T ECHNICAL INFORMATION

D2180

Subject ▶ Change of Adjuster rod and Nail plate

Model ▶ GN420C, GN01

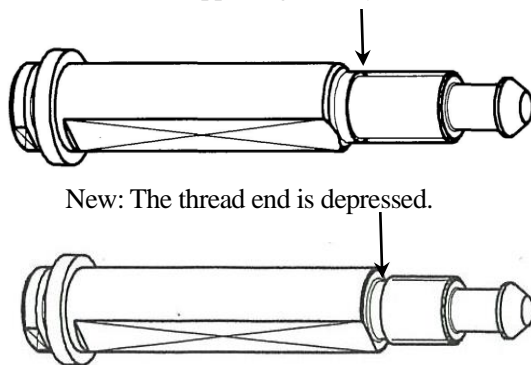
Description ▶ Adjuster rod and Nail plate will be changed to enhance the durability.

[1] Change of shape of Adjuster rod
Current: Thread disappears gradually on the end.

New: The thread end is depressed.

[2] Change of heat treatment and distinction mark of Nail plate:
Current: Carburizing and quenching Mark 1 or 2 on designated portion
New: Through hardening Mark A or B on designated portion

Item No.	Current part	Q'ty	I/C	H/S	S/P	New part	Q'ty	Note
012	ADJUSTER ROD	1	←	OK	D	ADJUSTER ROD	1	
	326246-3					327593-5		
010	NAIL PLATE	1	←	OK	D	NAIL PLATE	1	
	310524-1					313302-8
